MONITORING YEAR 7 ANNUAL/CLOSEOUT REPORT

LITTLE PINE III STREAM AND WETLAND RESTORATION PROJECT

Alleghany County, NC
NCDEQ Contract 6844
DMS Project Number 94903
DWR # 14-0041
USACE Action ID 2012-01299

RE: Draft Monitoring Year 7 / Closeout Report
Little Pine III Stream and Wetland Restoration Project
DMS Project Number 94903
Contract Number 6844
New River Basin - CU# 05050001 - Alleghany County, North Carolina

Groundwater Gage Plots (MY1 - MY6)

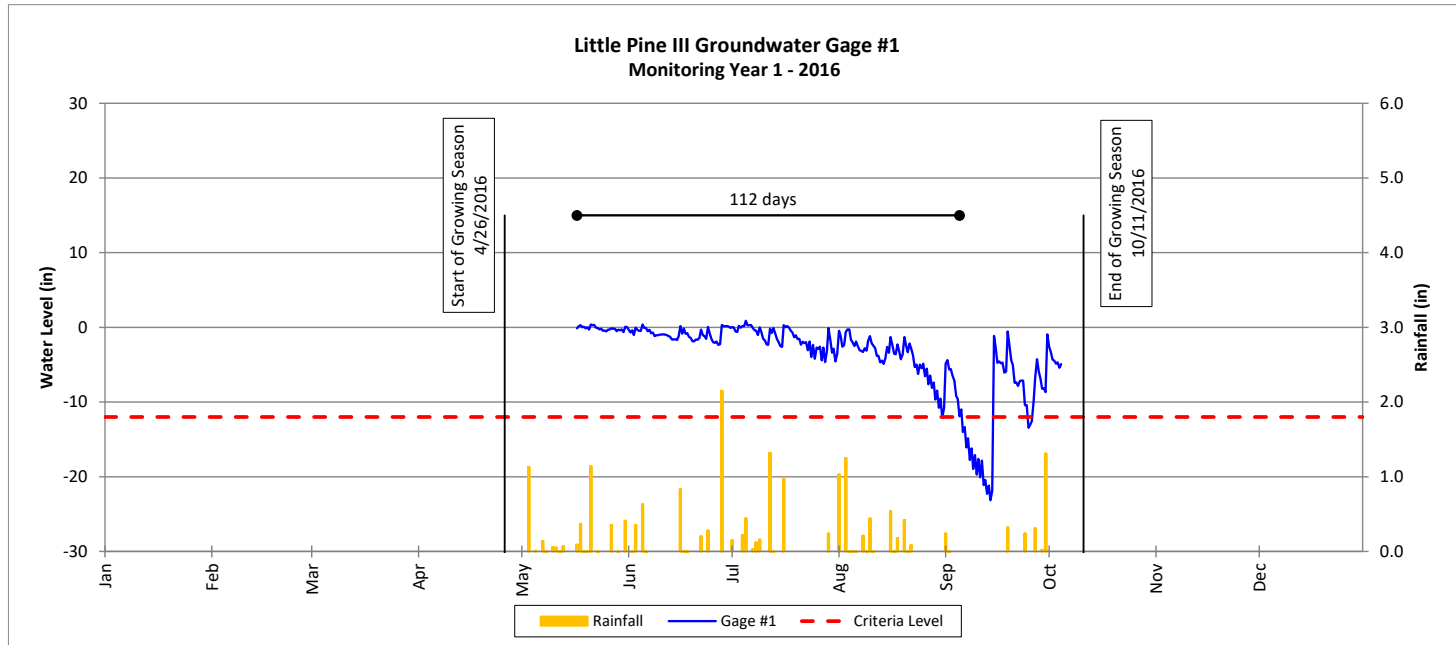
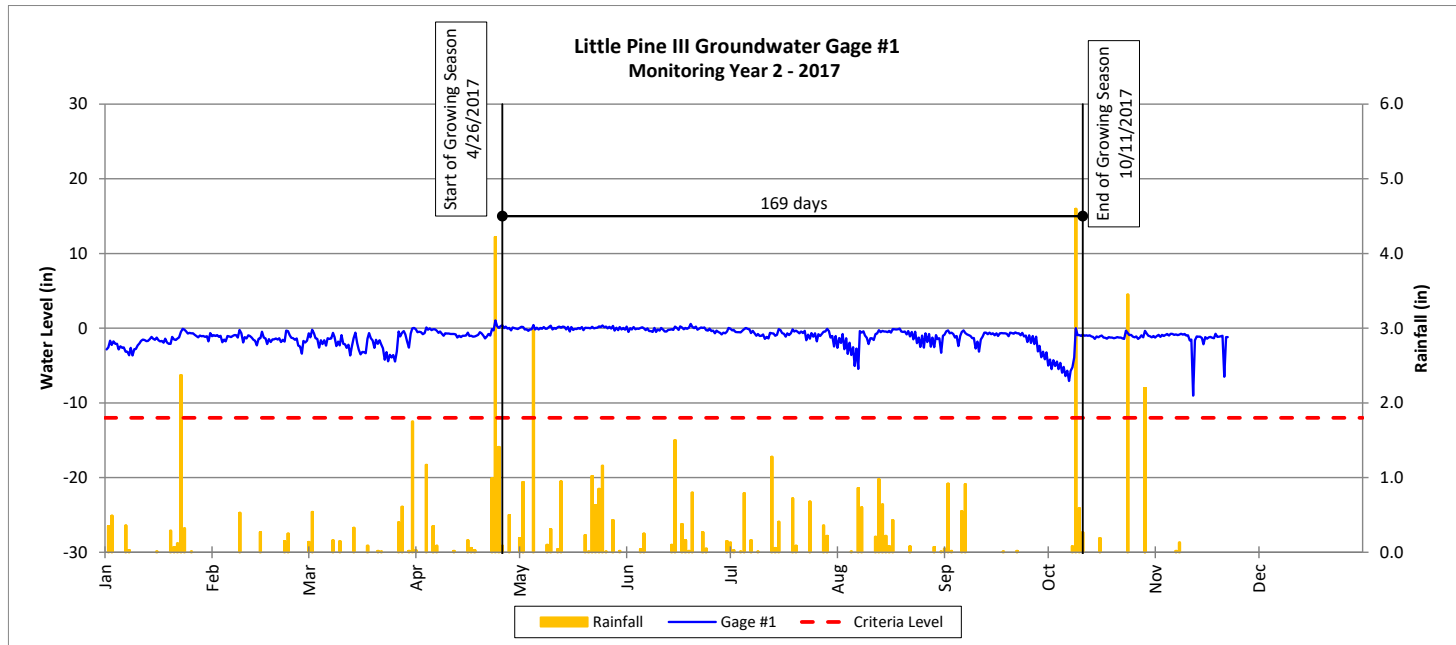
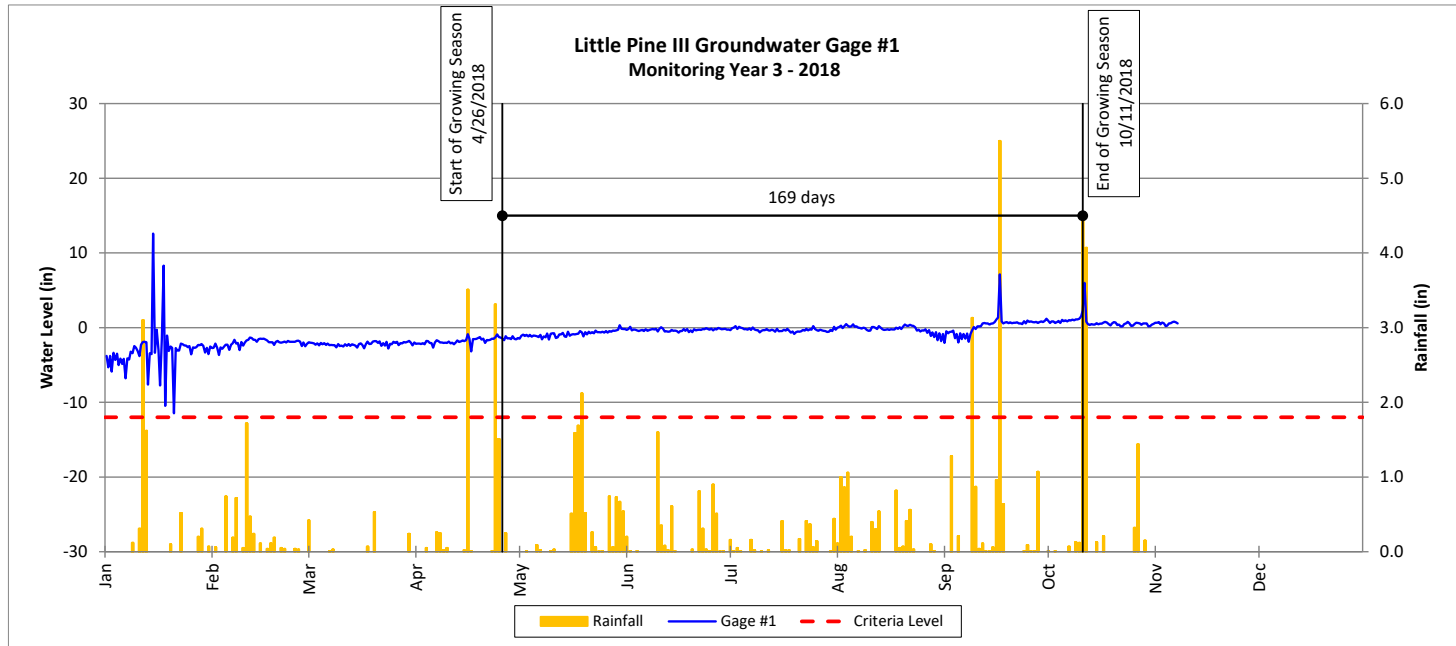
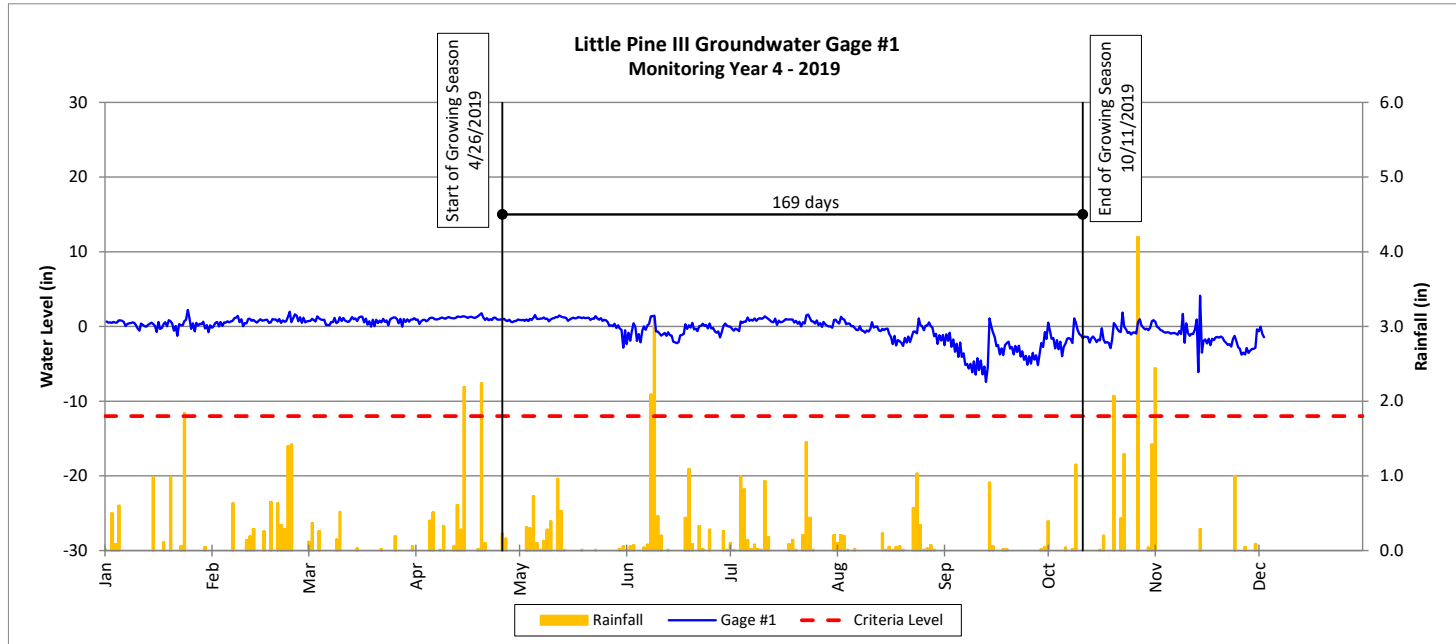
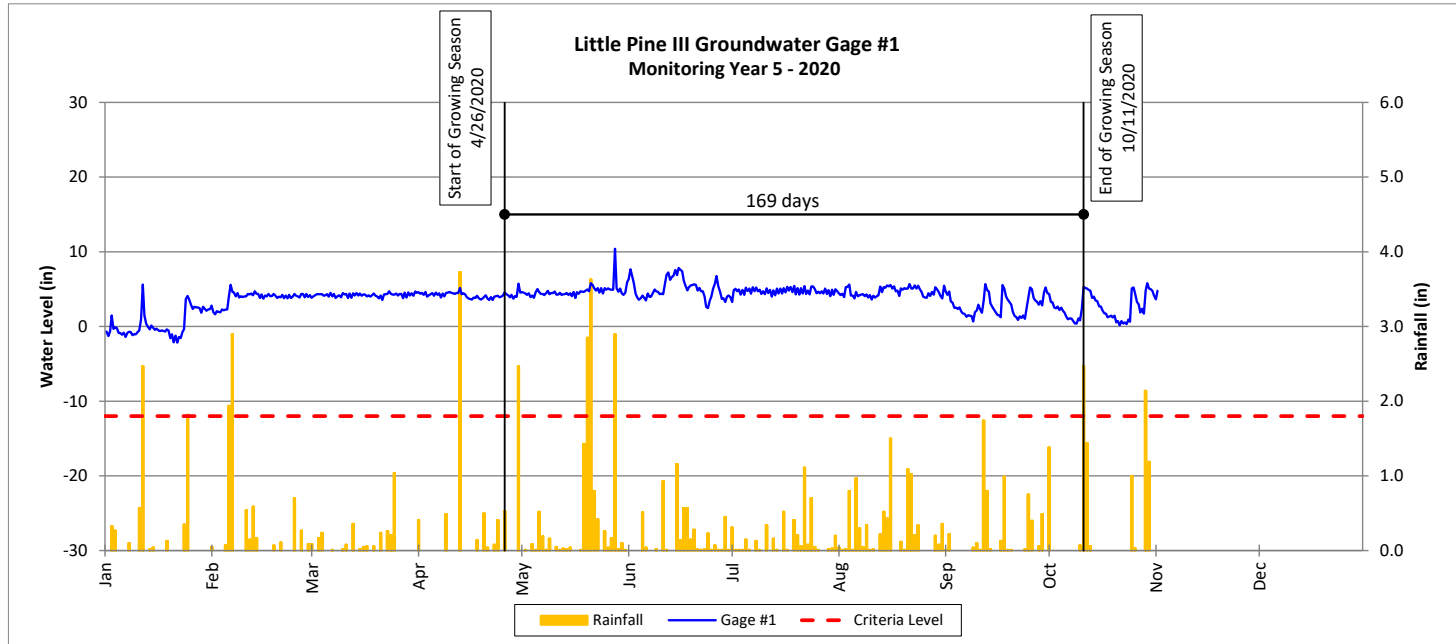
DMS comment: Please include GWG results for all years.

Wildlands response: The GWG plots have been added to Appendix 5.
